<b>SUNDRY NOTICES AND REPORTS ON WELLS</b> (DO NOT USE THIS FORM FOR PROPOSALS TO DRILL OR TO DEEPEN OR PLUG BACK TO A DIFFERENT RESERVOIR. USE "APPLICATION FOR PERMIT" (FORM C-101) FOR SUCH PROPOSALS.)		WELL API NO. 30-015-33030

2. Name of Operator OXY USA WTP Limited Partnership		6. State Oil & Gas Lease No. V-992
3. Address of Operator P.O. Box 50250 Midland, TX 79710		7. Lease Name or Unit Agreement Name Indian Basin 32 State

OXY USA WTP LP - Proposed  
Indian Basin 32 State #7  
API No. 30-015-33030

**CONDITIONS OF APPROVAL FOR PLUGGING & ABANDONMENT**

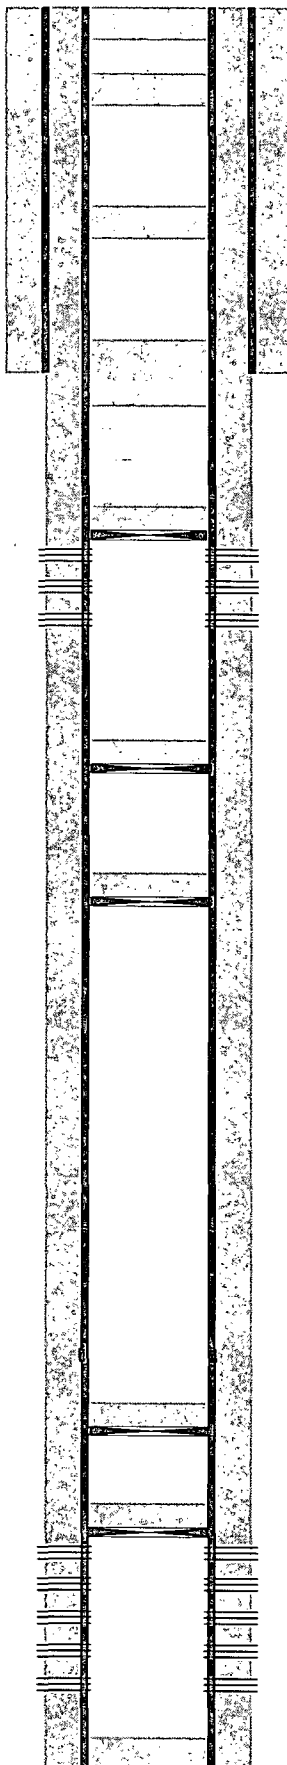
1. Produced water **will not** be used during any part of the plugging & abandonment operation.
2. Notify NMOCD Dist. 2 office at least 24 hrs before beginning work.

3. Closed Loop System is to be used for entire plugging operation. Upon completion, contents of steel pit are to be hauled to a permitted disposal location.

6. If work has not begun within 90 days of the approval of this procedure, an extension request must be filed, stating reason that well has not been plugged.

7. Every attempt must be made to clean the well bore out to below the perfs, before any plugs can be set, by whatever means possible.
8. Cement Retainers may not be used.

9. Squeeze pressures are not to exceed 500 PSI, unless approval is given by NMOCD.
10. Plugs may be combined after consulting with and getting approval from NMOCD.

11. Minimum WOC time for tag plugs will be 4 Hrs.
